Director-Infrastructure Projects  
Department of Planning and Environment  
GPO Box 39  
Sydney NSW 2001

**I strongly object to the Bicycle Path in Patmore swamp and object to the Extension of the Shared Pathway detailed in the Preferred Infrastructure Report (PIR) (Application number: SSI\_8931)**

**Figure 2 - Eastern routes for the Cycleway (Ref: EIS chapter 5, Figure 5-9)**

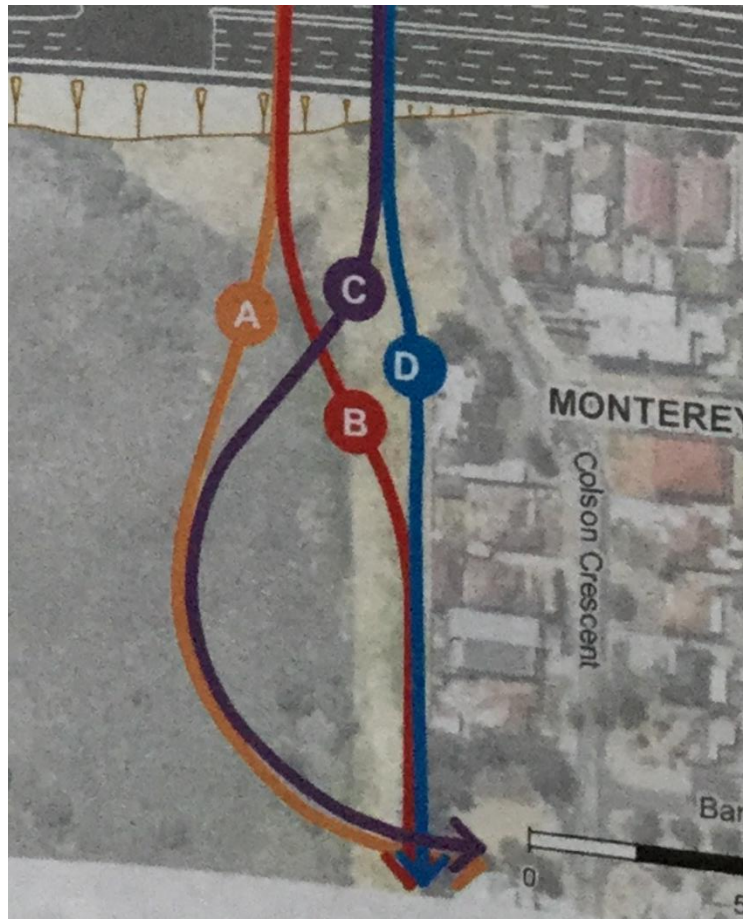
I have assessed the above Figure. The primary reason why the Eastern options were rejected by the RMS is because of privacy concerns for the residents near the proposed route. I have done a site visit on the Eastern side and have concluded the following:-

- Option A route is very far away from the one residential home in President Ave
- Option A at least 50 metres away from the five homes in Colston Crescent seen in the Figure 2.

Option A may visually impact 6 residential homes but this could be mitigated by excellent engineering solutions, such as a deeper S curve.

I do not understand why the same design principles to enhance visual amenity cannot be applied for the residents on Colston Ave.

**Figure 3: Cumulative Impacts on Patmore Swamp (Source: EIS Chapter 12, Figure 12-2 – Native vegetation communities within the study Area, Page 12-13).**

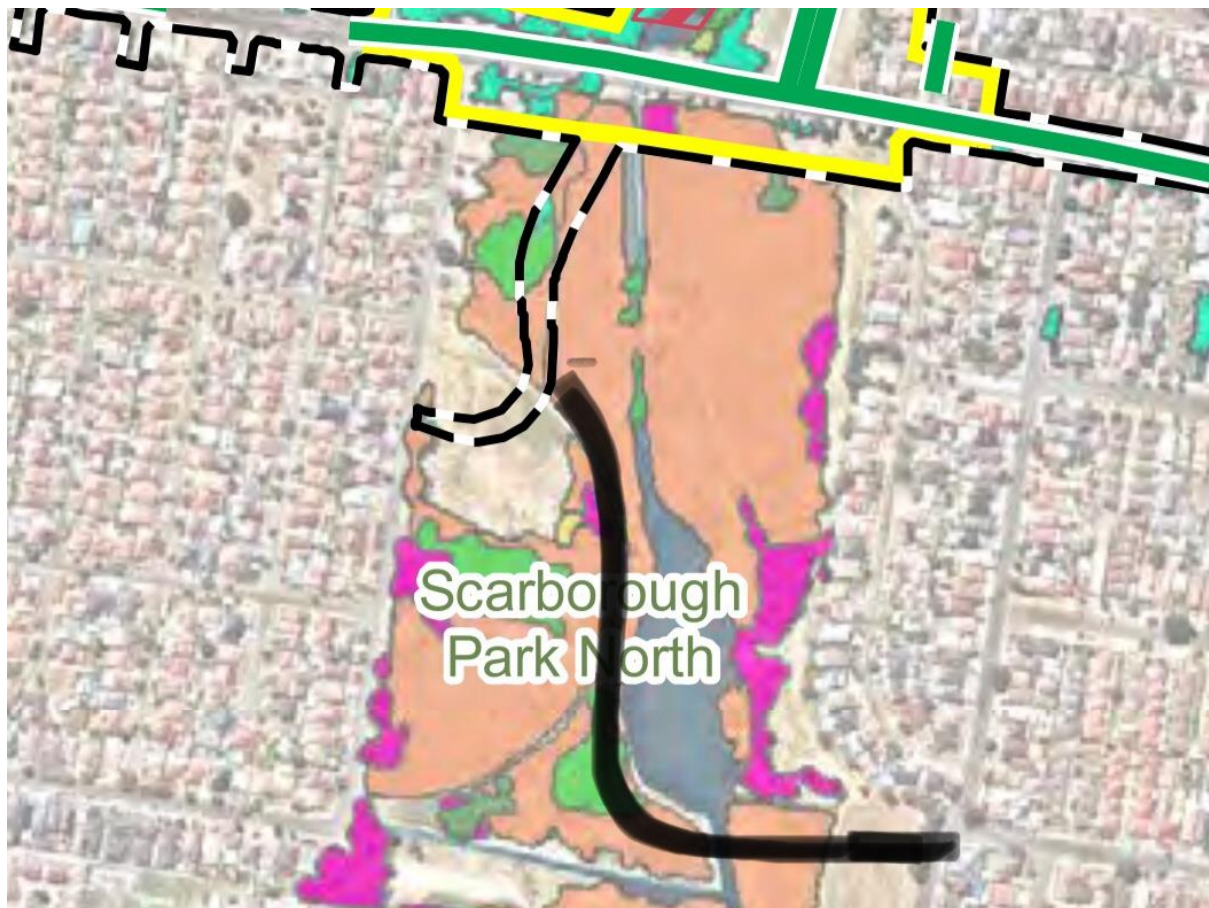
When I look Figure 3, it does appear that the RMS have **targeted all EEC** within Patmore Swamp. The proposed route goes through the EEC instead of planning the route around this endangered vegetation.
